**MEETING NOTICE – SITE REVIEW COMMITTEE**

**5. DISCUSSION AND ACTION - 582 Larsen Orchard Pkwy, HB-3260; New 4-story 25,380 Square Foot Mixed Use Commercial/Retail/Residential Building (Page 3)**

**RE:** 582 Larsen Orchard Pkwy, HB-3260; New 4-story 25,380 Square Foot Mixed Use Commercial/Retail/Residential Building

**ISSUE:** Discussion and action on a new 4-story 25, 380 Square Foot Mixed Use Commercial/Retail/Residential Building and associated site improvements

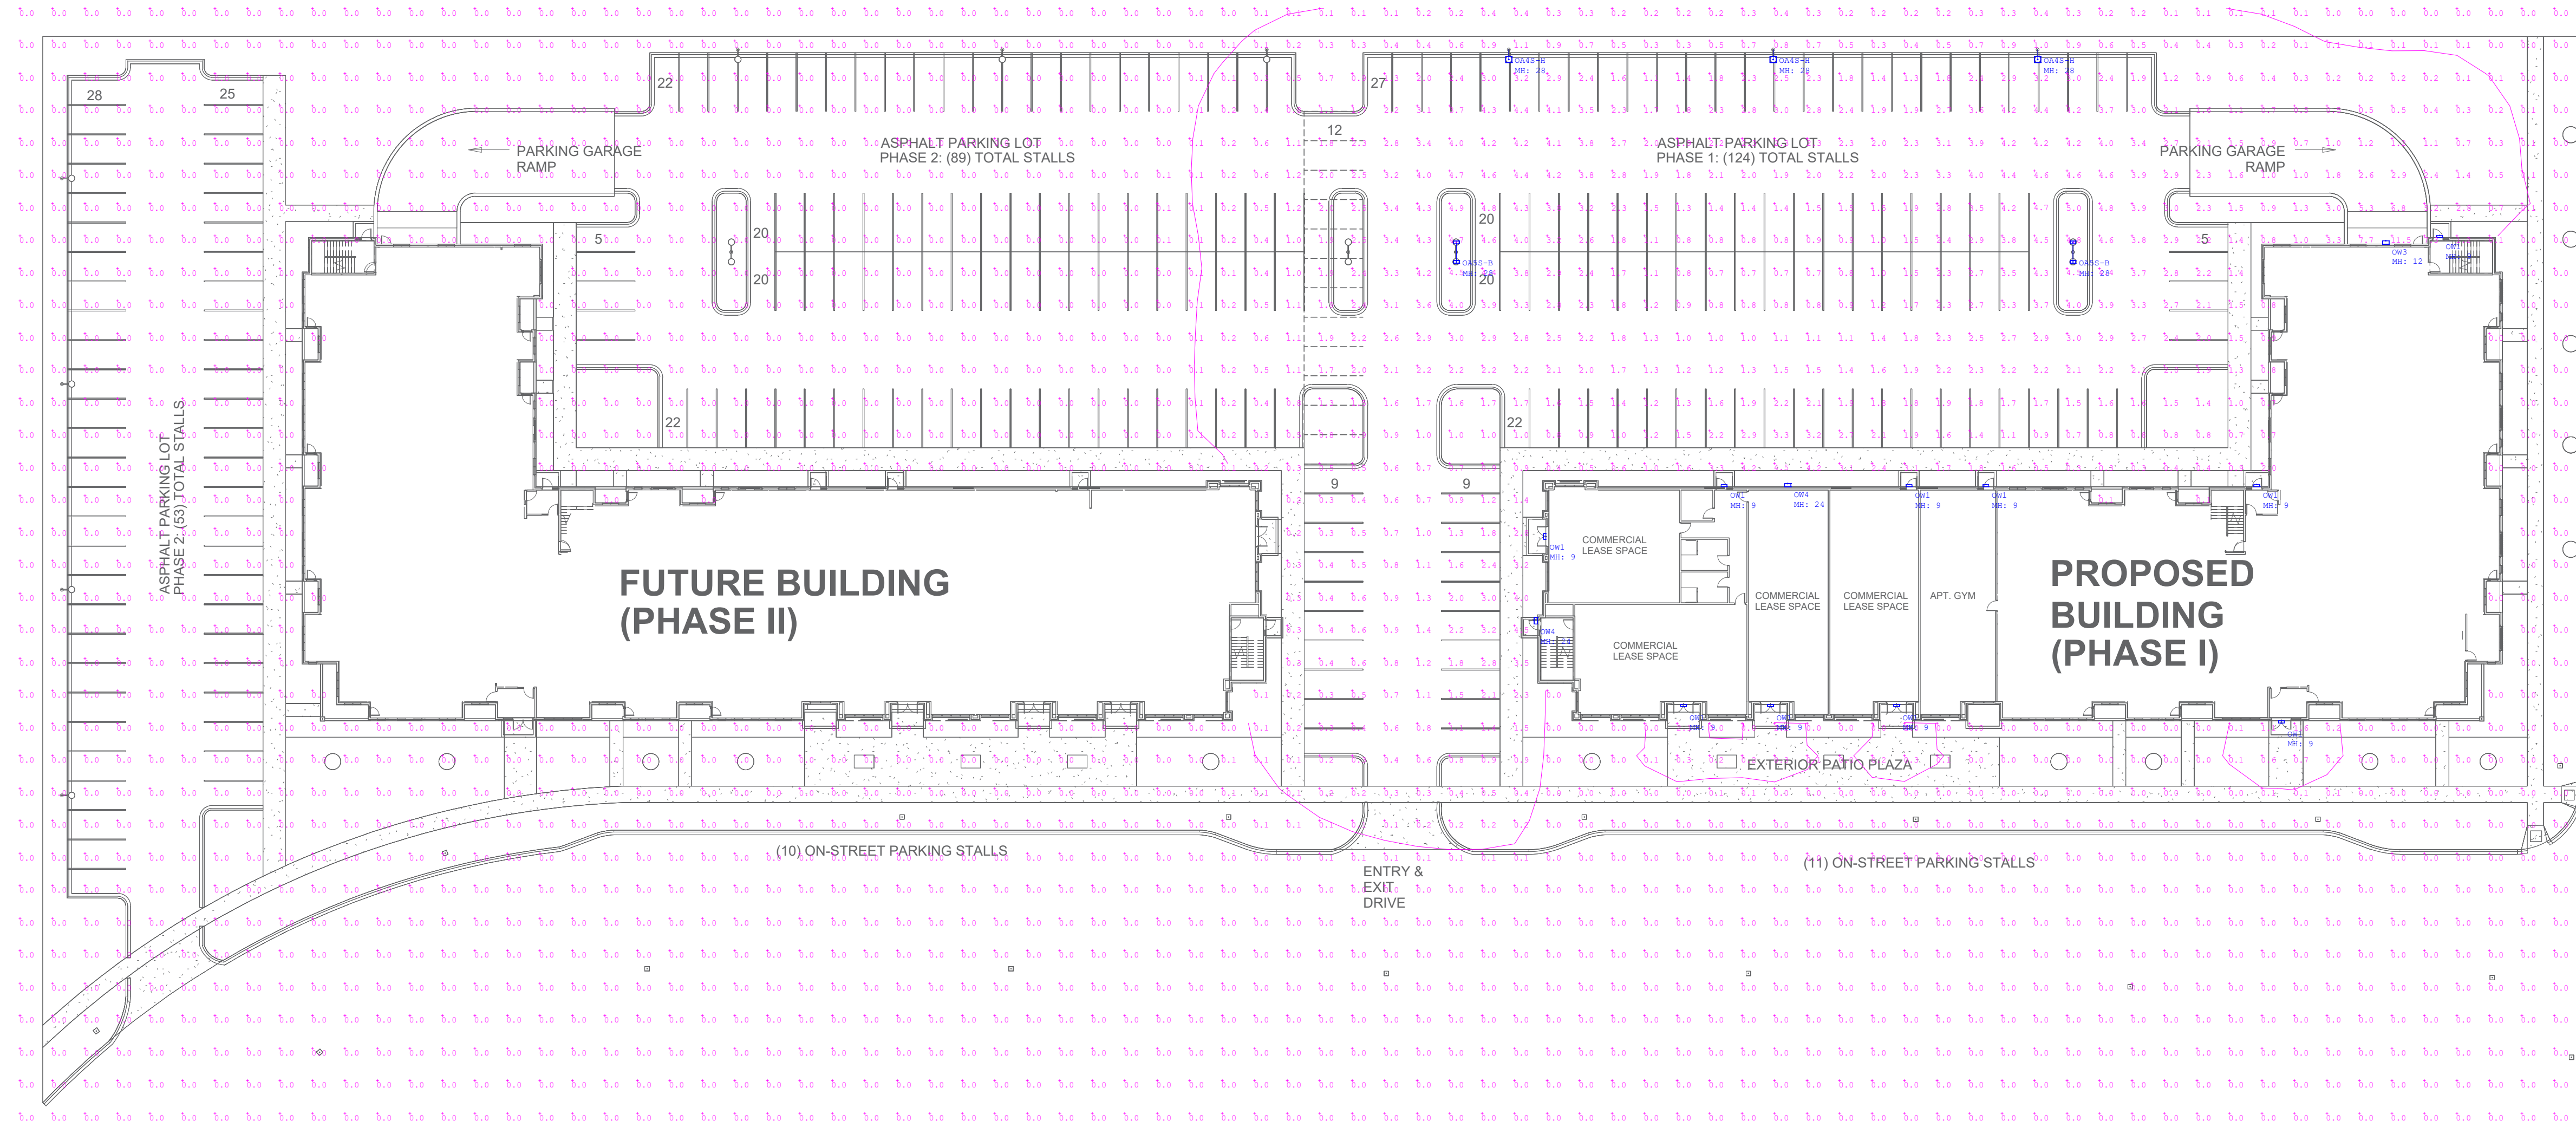
**Section 4, Lighting:** Parking and drive areas are proposed to have 5 pole light poles (2 will have double light fixtures) that are 28' above grade (25' pole and 3' base). Additionally, there is proposed wall mounted lighting around the perimeter of the structure to illuminate the overall structure, but also the ingress/egress points
